# TTS Middle and Bottom Stages

# Triple Test Stand Front End CPU ADC Connections

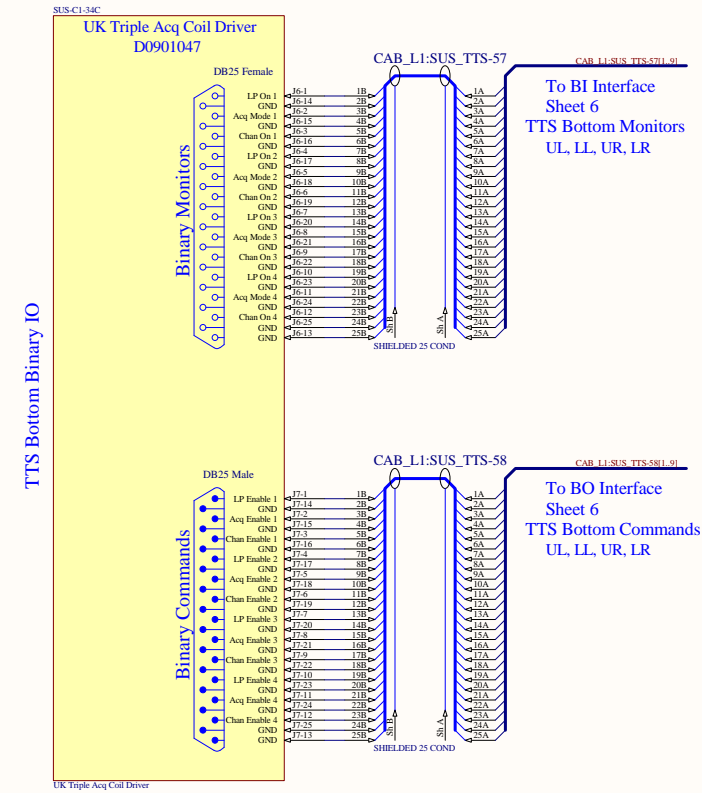
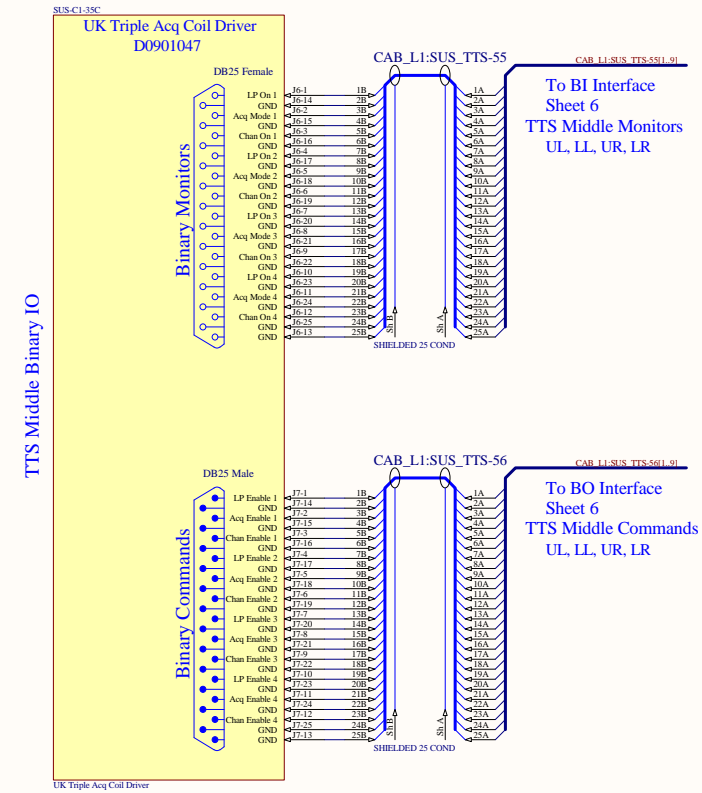
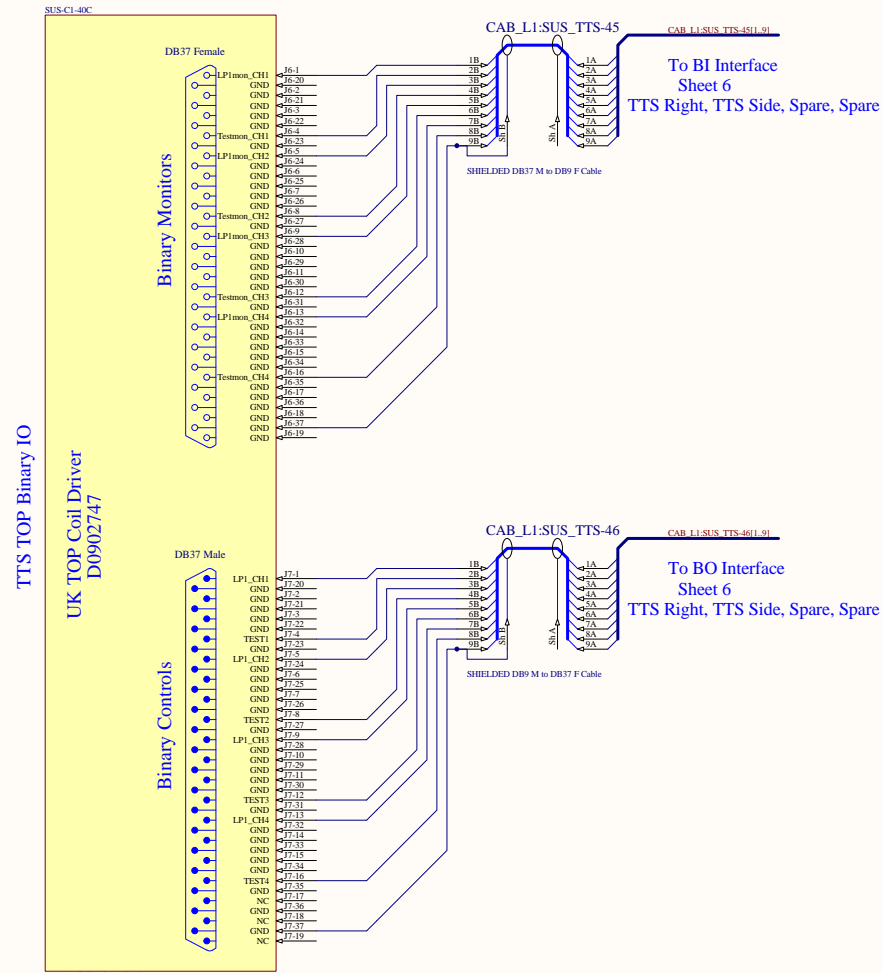
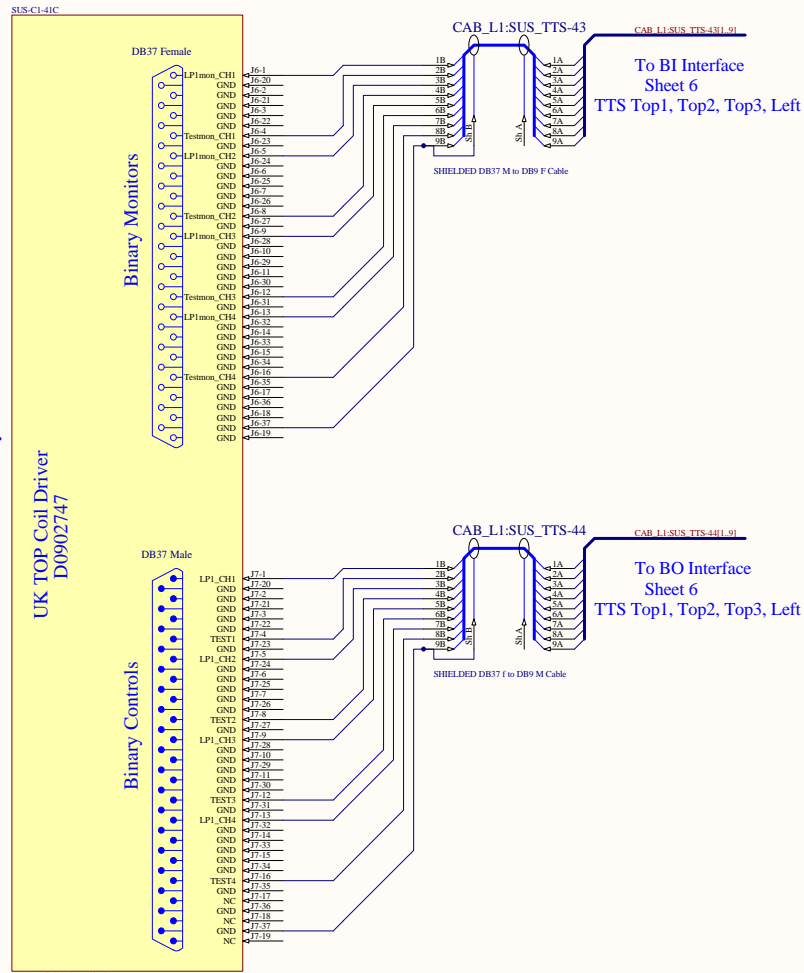
Need to fix channel index and cable numbers
